Estrella Substation and Paso Robles Area Reinforcement Project

Recirculated Portions of the Draft Environmental Impact Report

SCH #2018072071

November 2021

Figure 2-11.
Preliminary Substation Layout

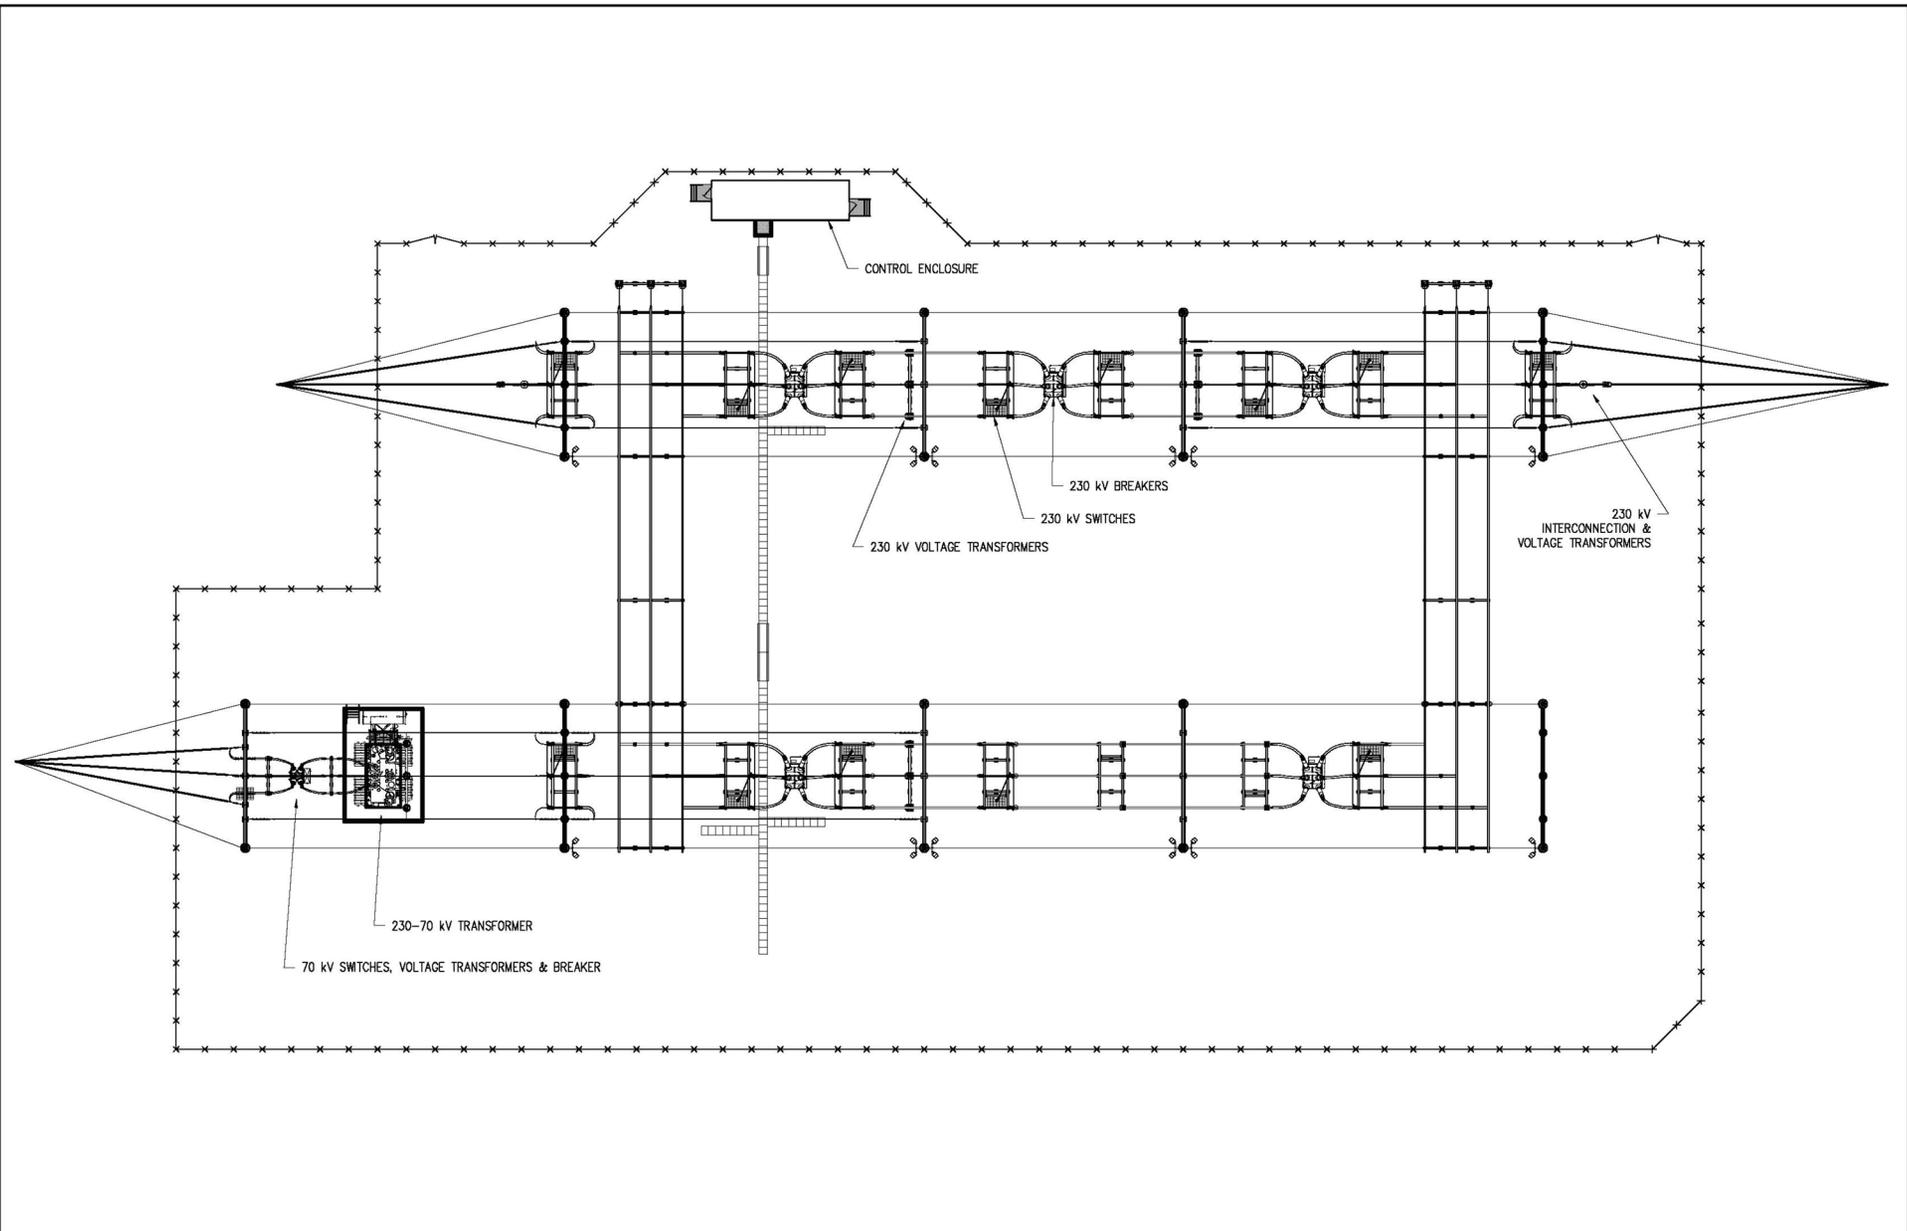
- **Estrella Substation Layout and Orientation.** The Estrella Substation layout and orientation are revised to move the substation facilities slightly closer to Union Road. Other minor changes to equipment layout within the substation are reflected in updated figures. Changes to the substation layout and orientation are reflected in the revised Figures 2-11, 2-12, 2-13, 2-15, and 2-18.

Figure 4.2-2
Williamson Act Lands

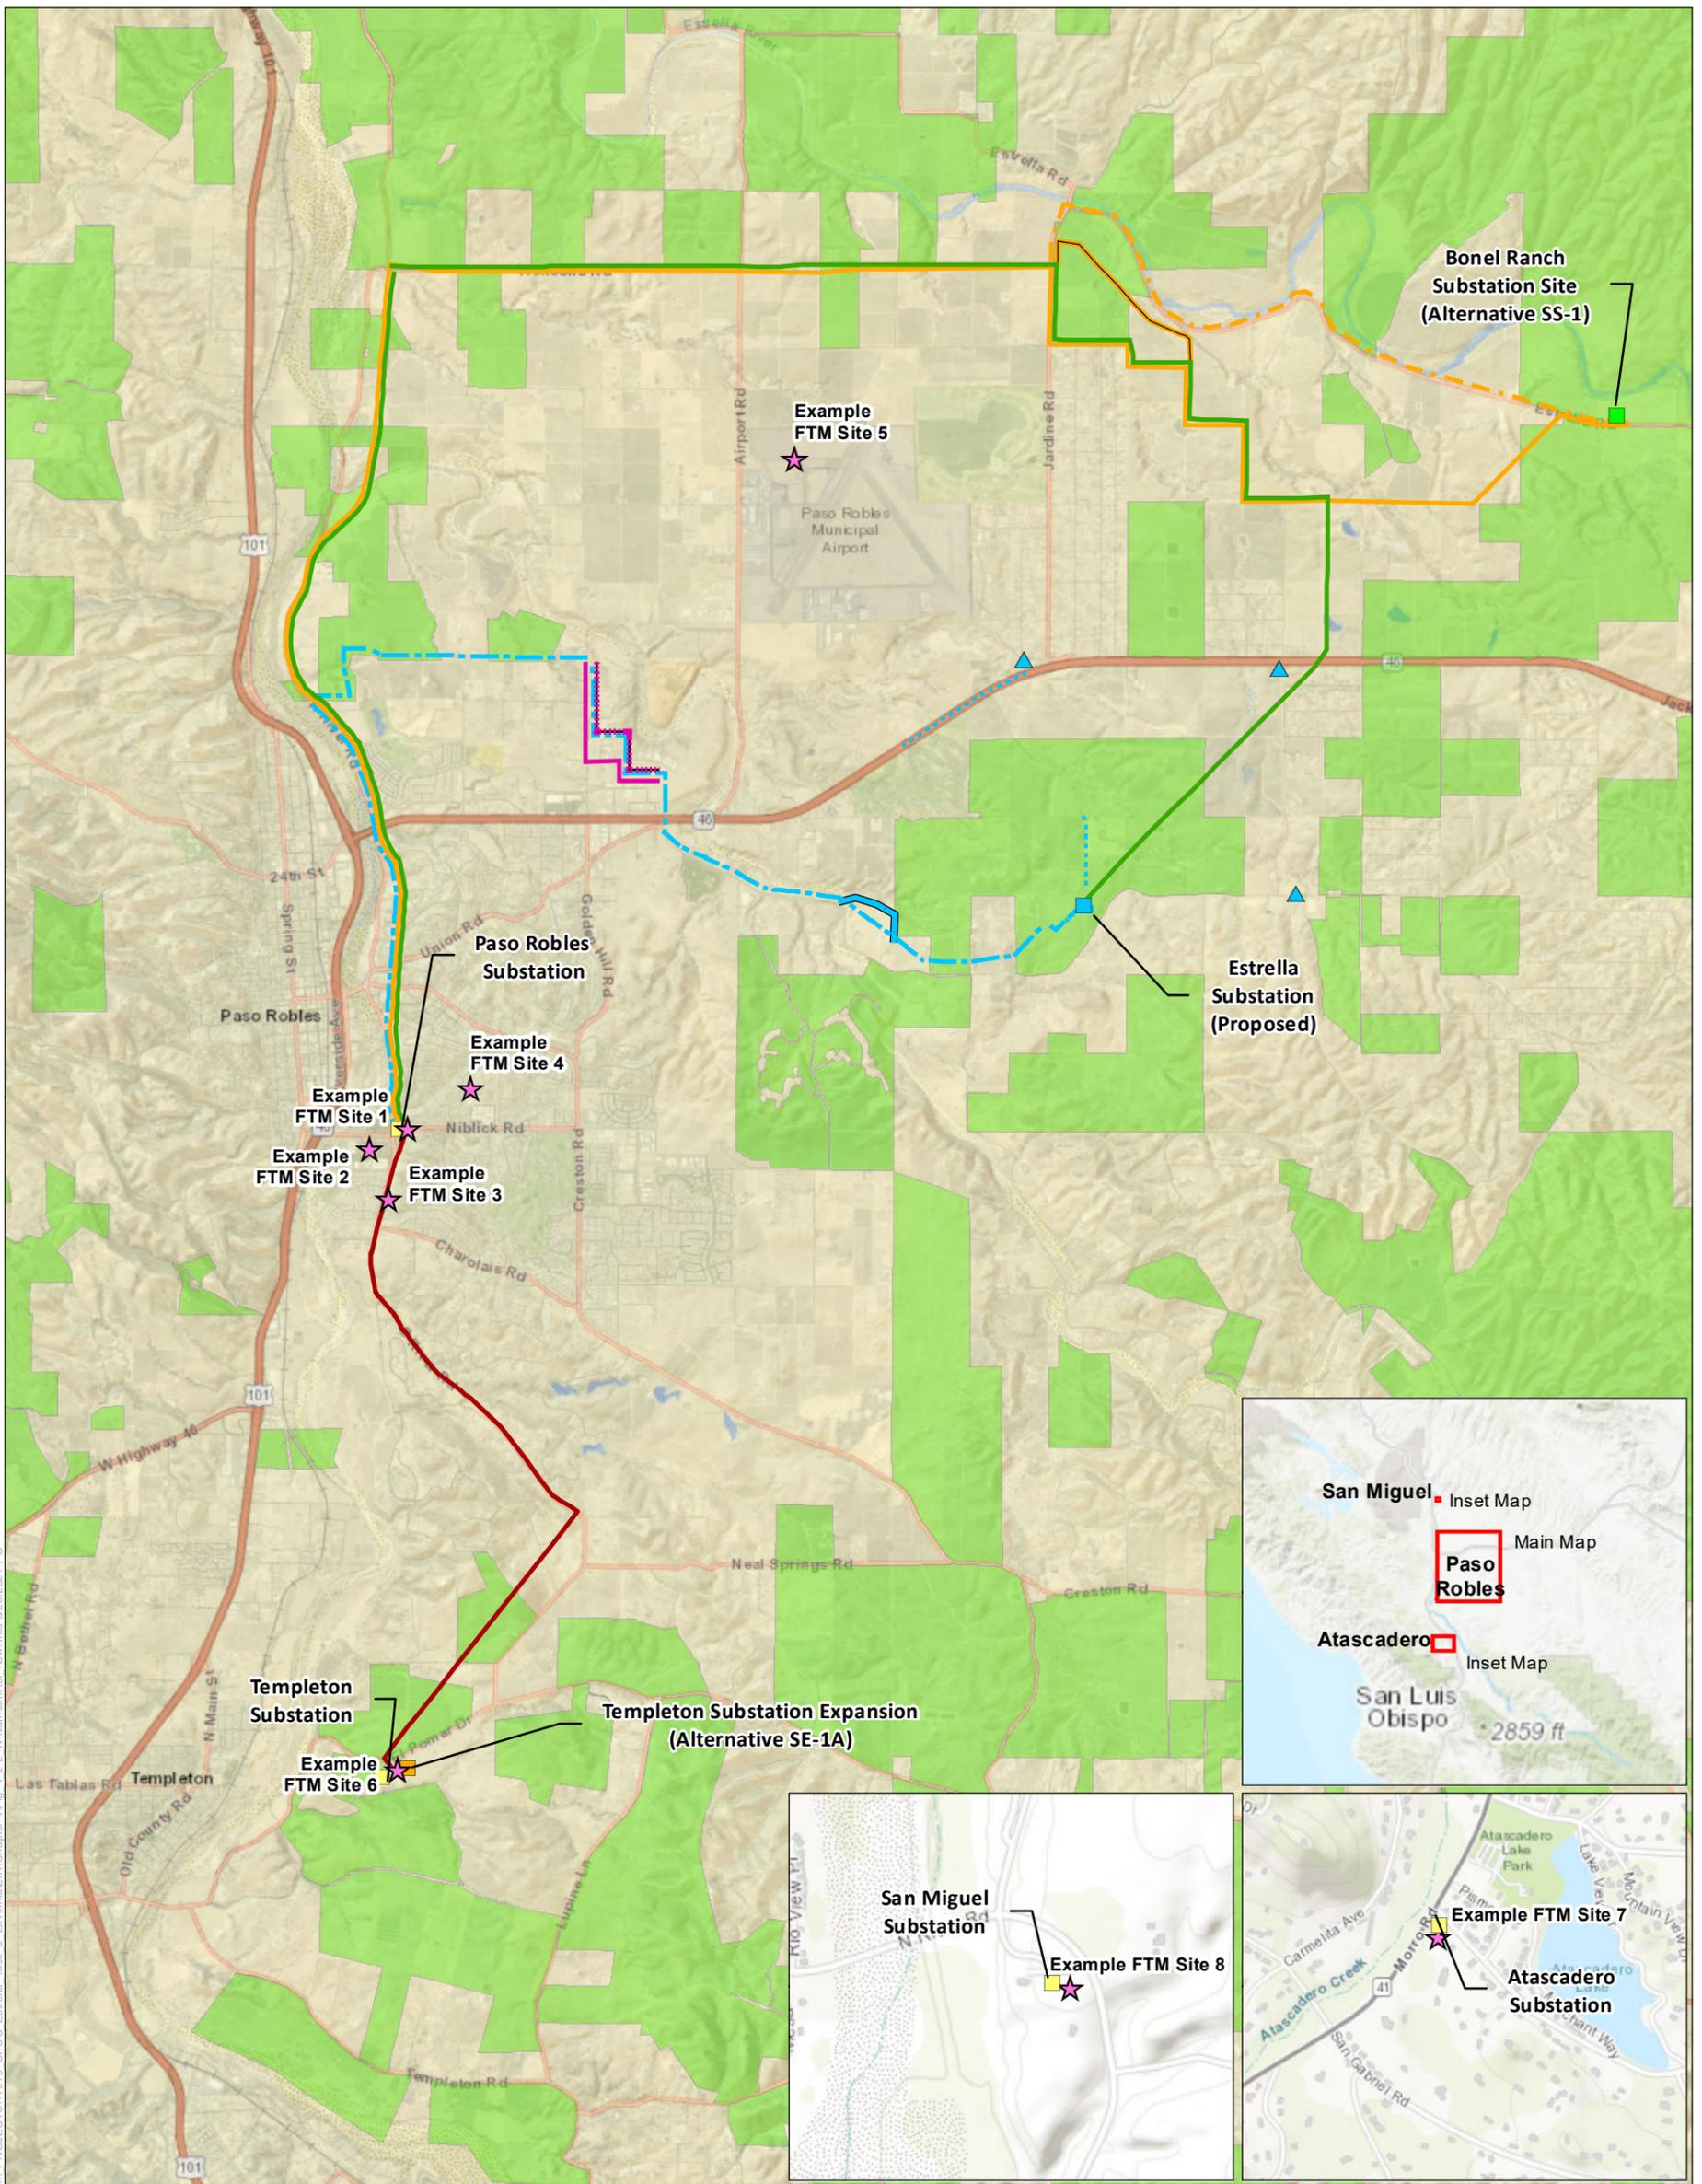
With respect to the updated data for Williamson Act contracts in the Proposed Project and alternatives vicinity, Figure 4.2-2 was revised to incorporate the updated data (San Luis Obispo County). This updated data did not change the significance conclusion or discussion for the Proposed Project or any of the alternatives, except for Alternative SS-1, with respect to potential conflicts with a Williamson Act contract (Impact AG-2). The discussion under Impact AG-2 for
